B.P. FILE No. 4 of 1941.

19A-KEB.

Reference No. B. S. P. 71/41

Re:- Plot No.19A K.E.B, Artillery Maidan Qr.

GROUND FLOOR PLAN.

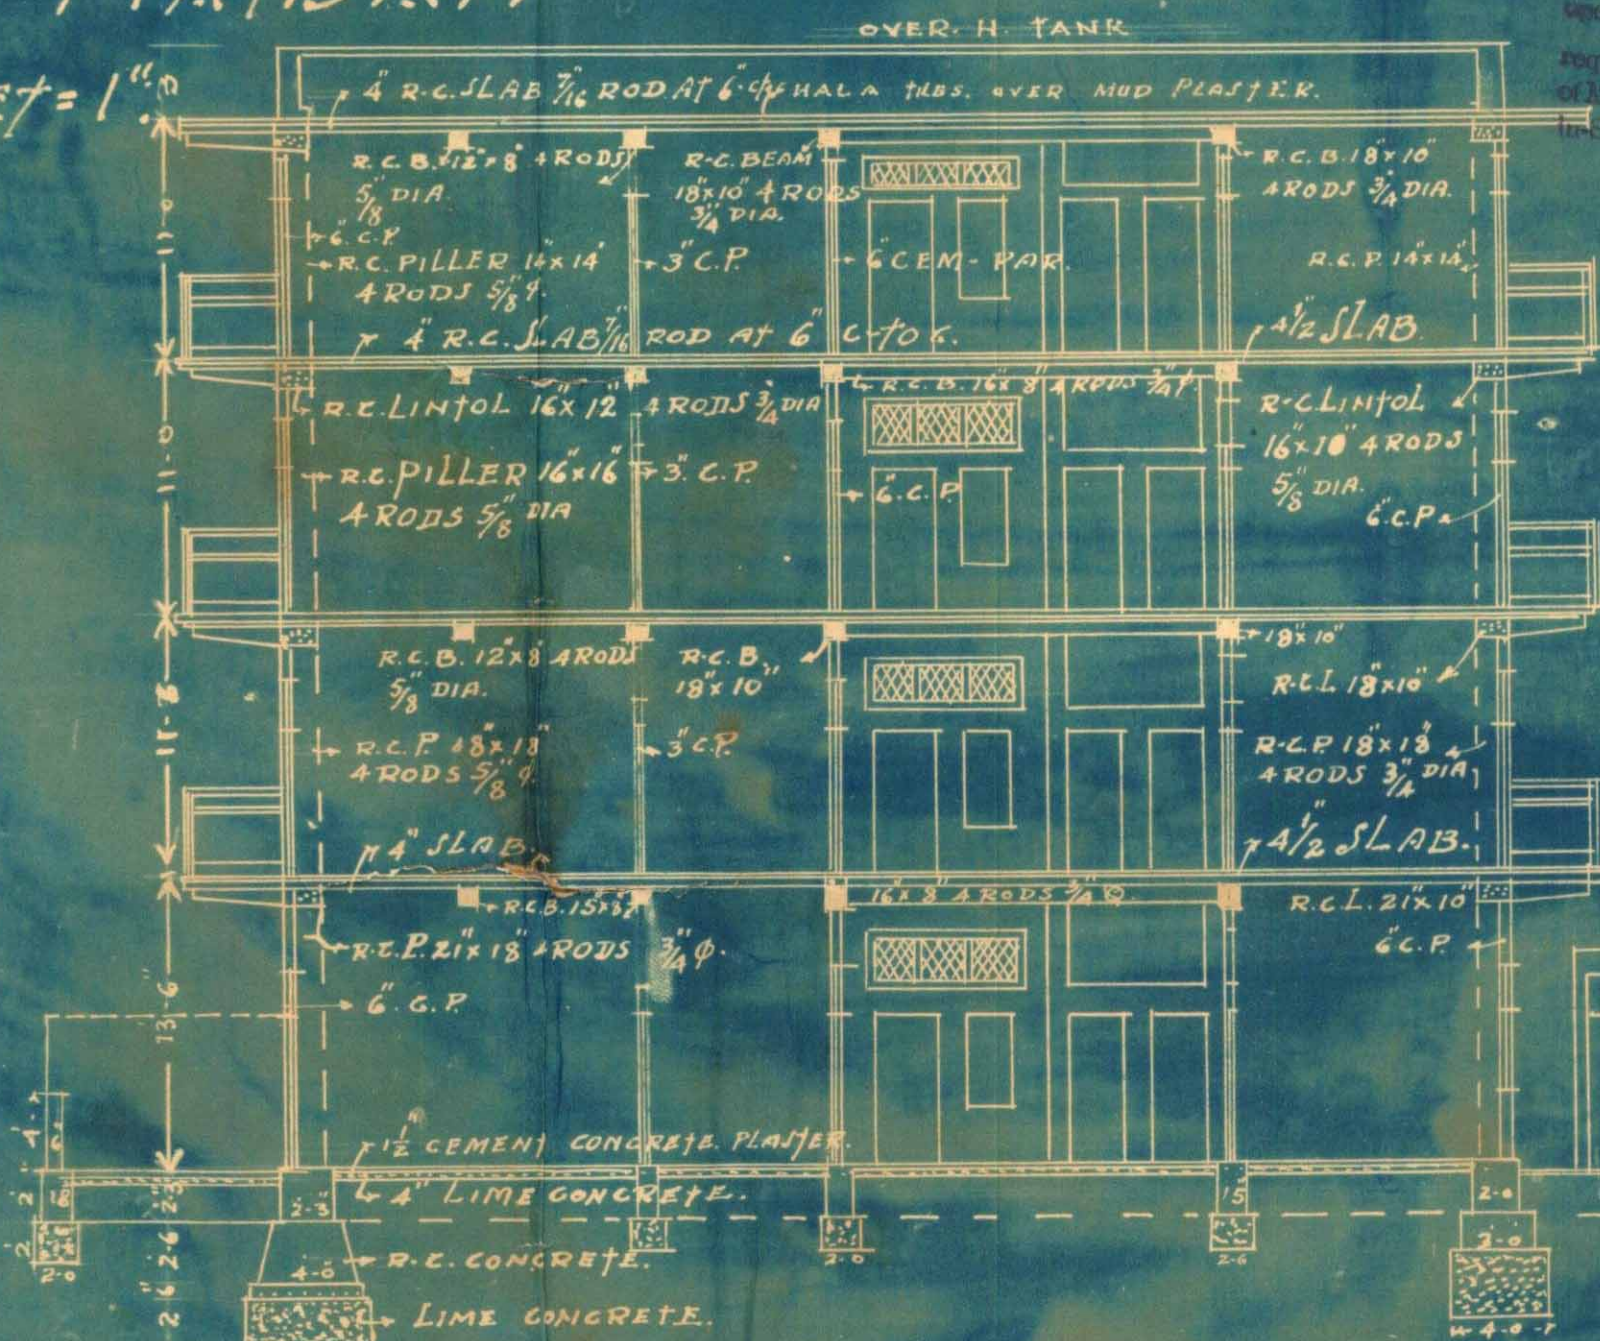
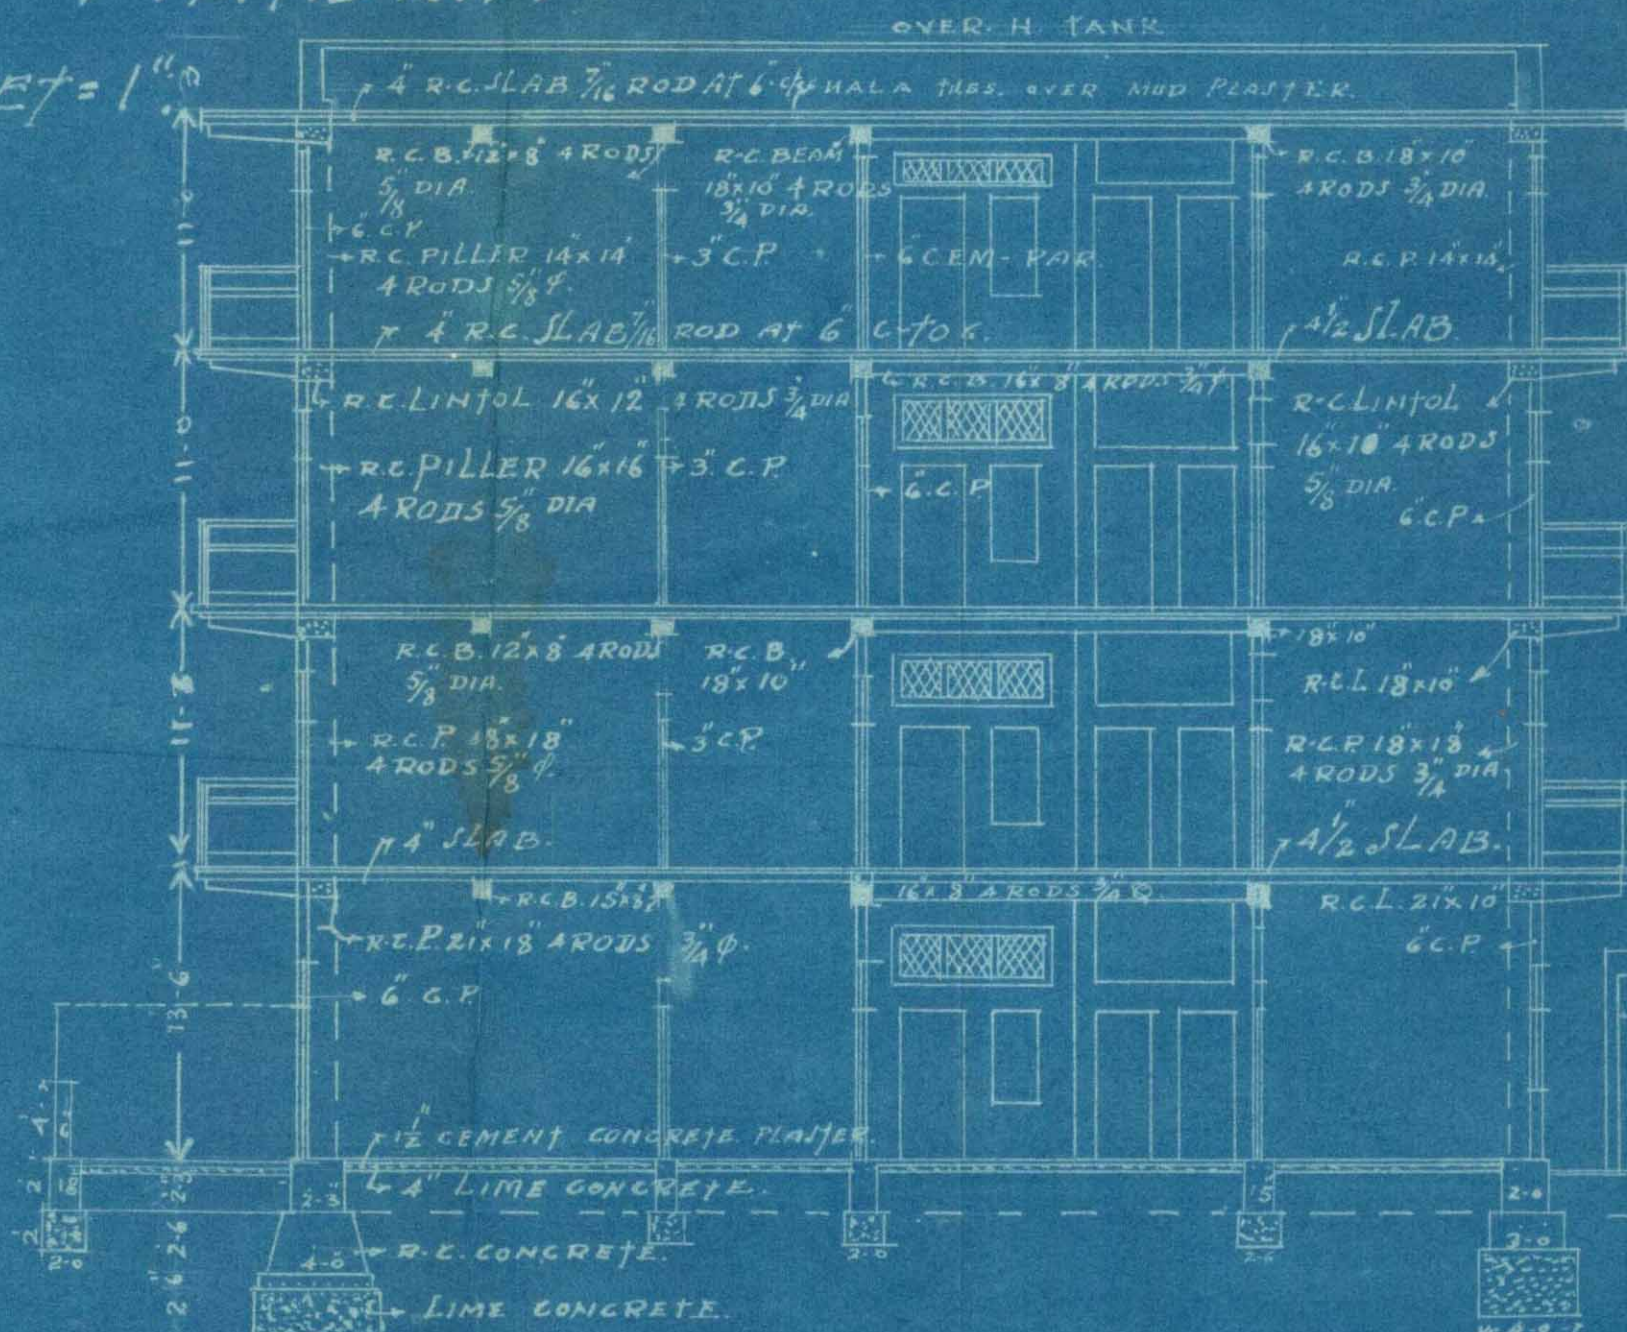
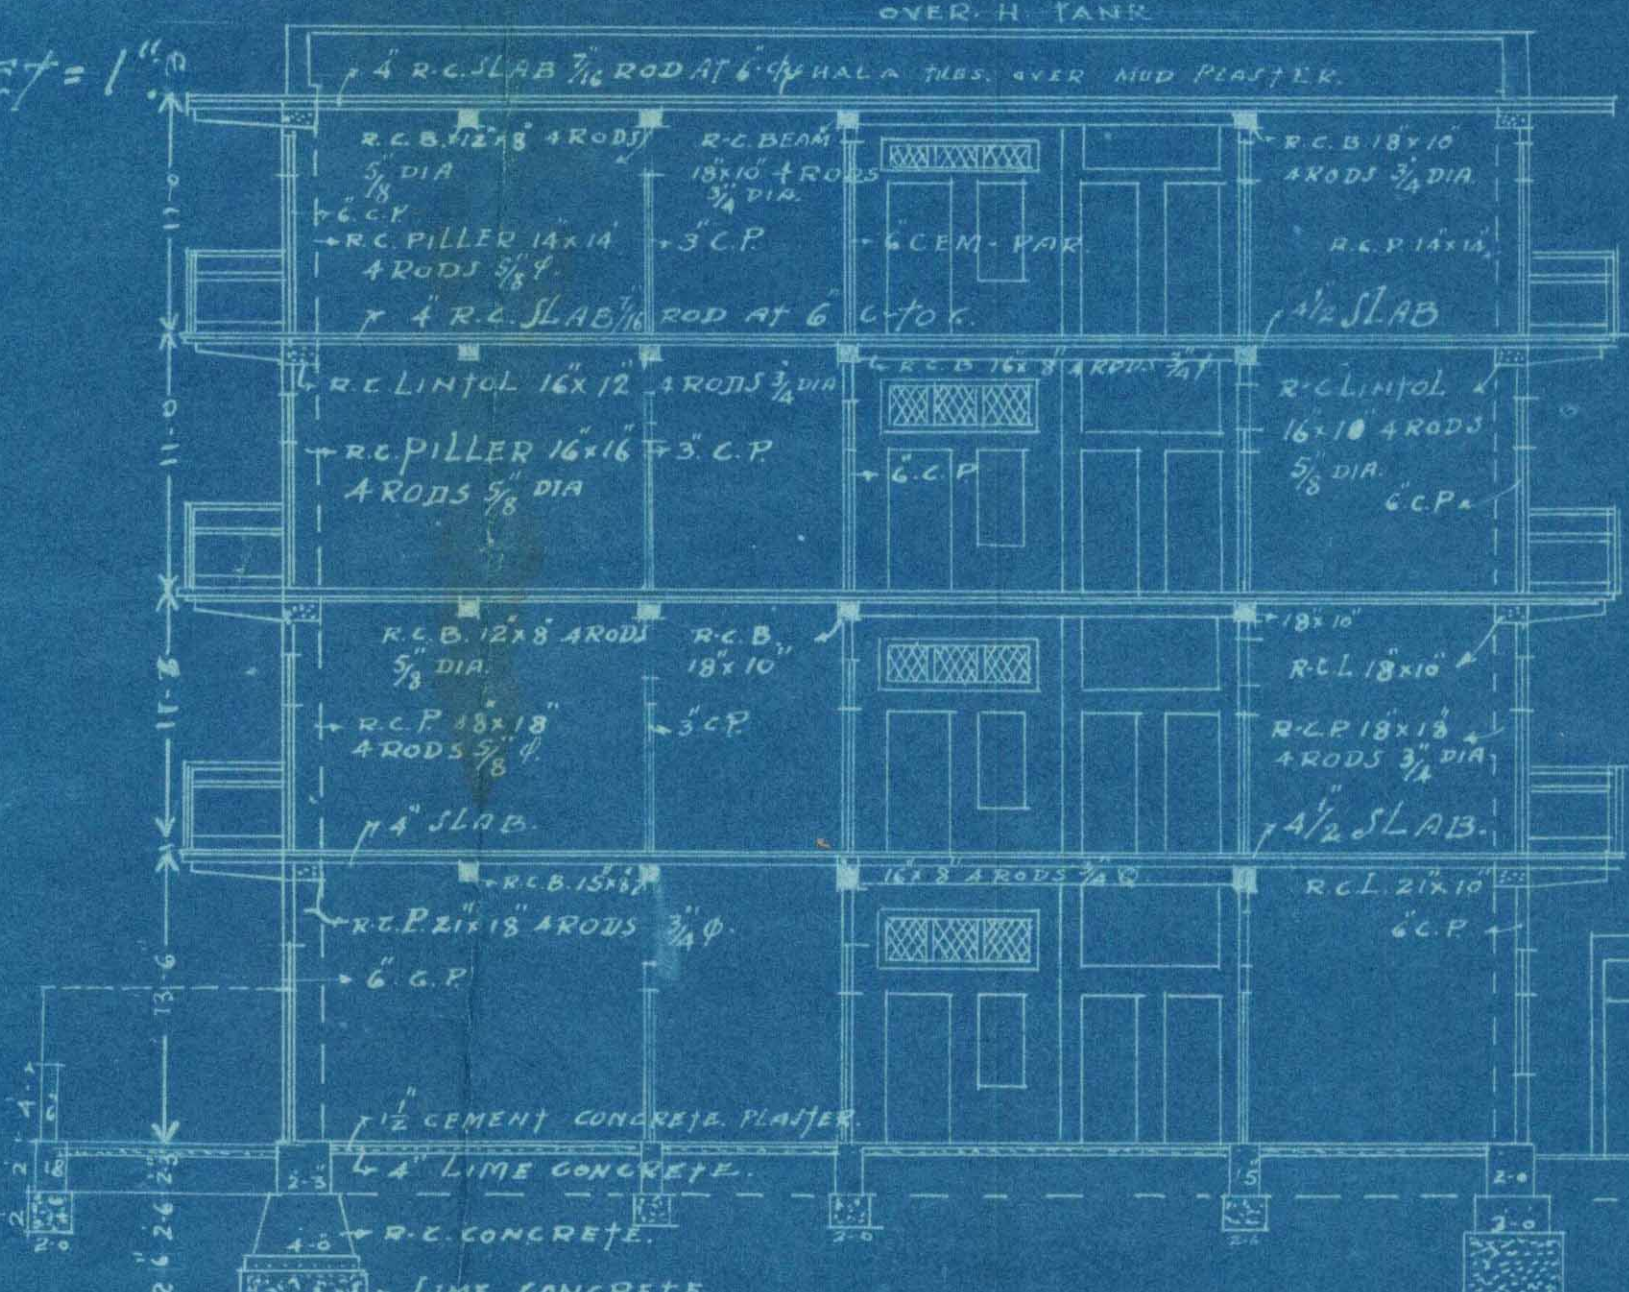
The architect states that on the ground-floor both ^{the} front & rooms
 will be used as one tenement. There is a staircase & ^{a passage} ~~tenement~~
 between the two rooms. Orders are requested if the two rooms
 be allowed as one tenement.

- (1) Windows from W.C.opening into store room is deleted.
- (2) Store room will be used as store & I have mentioned this on the plan also. As regards balconies of store rooms, this being on west its balcony will be useful for sitting during summer days.Hence there should be no objection from your side.

- (3) 'A'form is sent to Estate Board.
- (4) Sketch.is approved by K.E.B.
- (5) These are not one room tenements and moreover area of Main room is more than 1403ft.

- (6) Partitions in between room & Verandahs is kept 7½' high this is allowable.
- (7) Kitchen in the rear tenement is provided with continuous ventilator.

(1) Submitted. One-roomed tenements are not allowed in K.E.B. area.

1ST 2ND & 3RD FLOOR PLAN

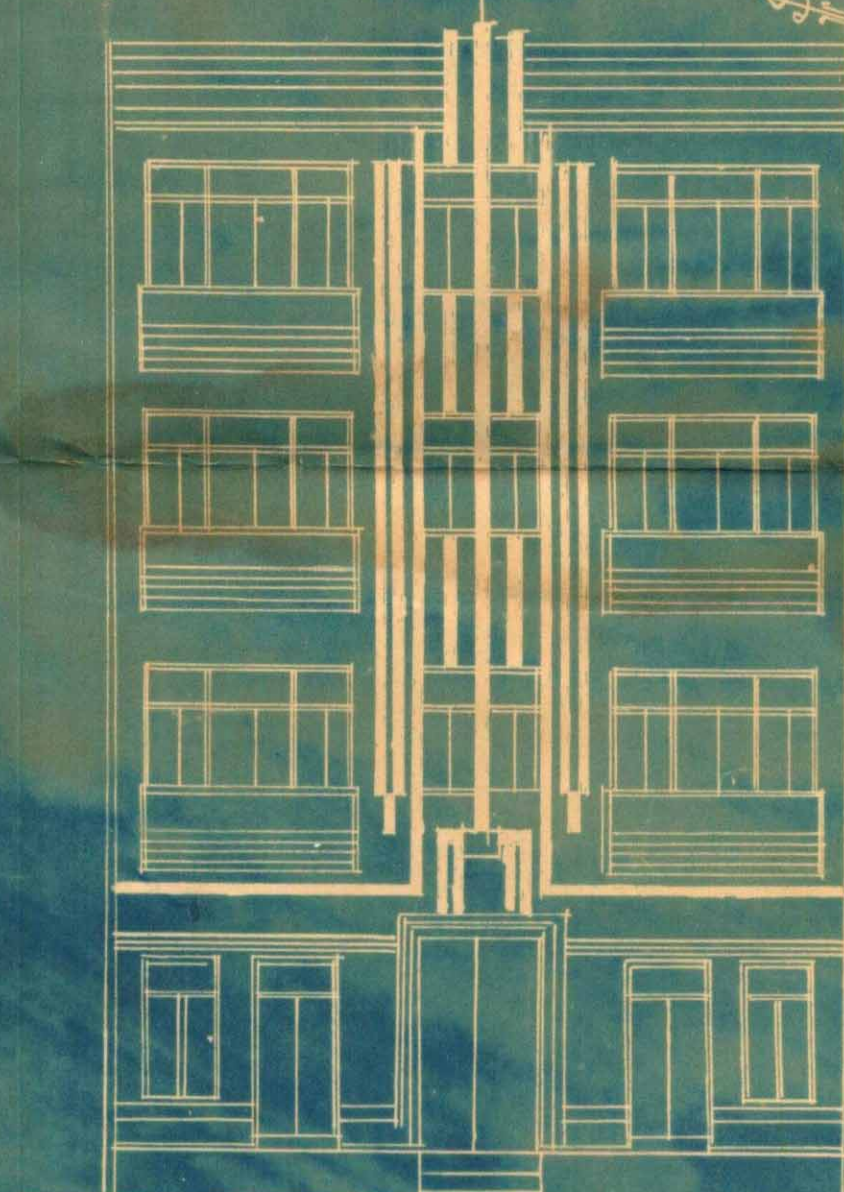
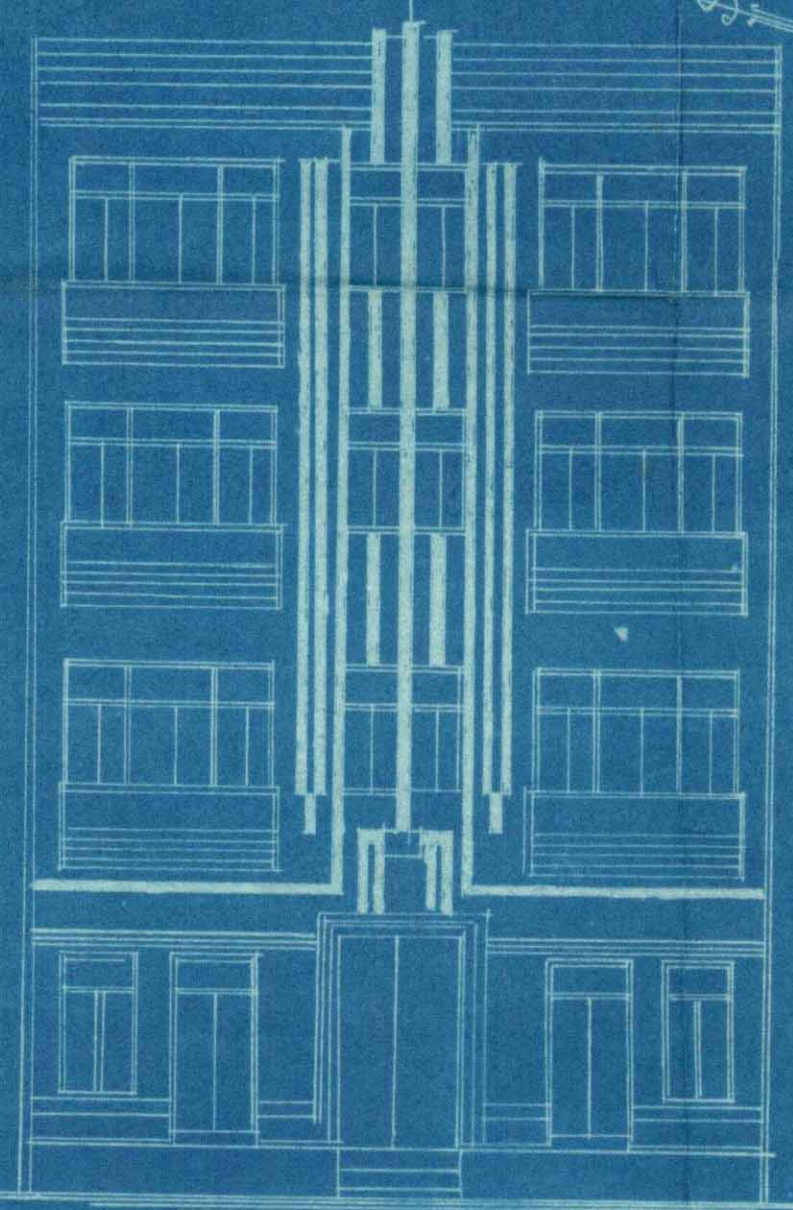
- (8) Through ventitor is now provided.
- (9) Store room being on West, These balconies will be an asset in Summer, moreover such store rooms have balconies of artillery Maidan.
